## Access Compliance Report Public Rights-of-Way (Curb Ramps)

Intersection ID: 15470 Main Street: AMITY\_SPRINGS\_DR Cross Street: THORN\_GROVE\_LN Location: W

ADA ID: 766B6C816E1A Ramp Type: Perp Initial Pass/Fail: Fail Overall Compliance: No Severity Score: 21.25

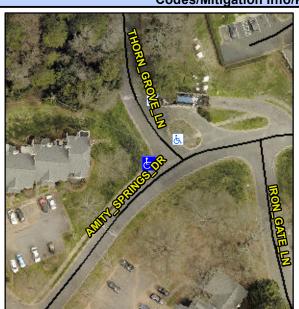
Not Found, R304.5.1, R304.5.3

Field Measurements/Component Compliance						
Compliance Description		Data	Compliance Description		Data	
	N/A	Ramp Length (in)	68.0	Yes	Ramp Slope (%)	7.0
	No	Ramp Width (in)	46.0	No	Ramp XSlope (%)	5.4
	N/A	Flare Type LT	N/A	N/A	Flare Type RT	N/A
	N/A	Flare Slope LT (%)	N/A	N/A	Flare Slope RT (%)	N/A
	N/A	Flare Traversable LT?	N/A	N/A	Flare Traversable RT?	N/A
	N/A	Landing Length (in)	N/A	N/A	DWS Provided?	N/A
	N/A	Landing Width (in)	N/A	N/A	DWS Contrast?	N/A
	N/A	Landing Slope (%)	N/A	N/A	DWS Length (in)	N/A
	N/A	Landing X Slope (%)	N/A	N/A	DWS Full Width?	N/A
	N/A	Landing Curb? (Y/N)	N/A	N/A	DWS Offset (in)	N/A
	N/A	Shared Landing?	N/A			
	N/A	Gutter Ponding?	N/A	N/A	Gutter Slope (%)	N/A
	N/A	Gutter Lip Ht (in)	N/A	N/A	Gutter X Slope (%)	N/A
	N/A	Painted X Walk1?	No	N/A	Painted X Walk2?	N/A
		X Walk 1 Direction	To NE		X Walk 2 Direction	N/A
	N/A	X Walk 1 Width (in)	N/A	N/A	X Walk 2 Width (in)	N/A
		X Walk 1 Slope (%)	0.4		X Walk 2 Slope (%)	N/A

Remove & Replace Entire Ramp.
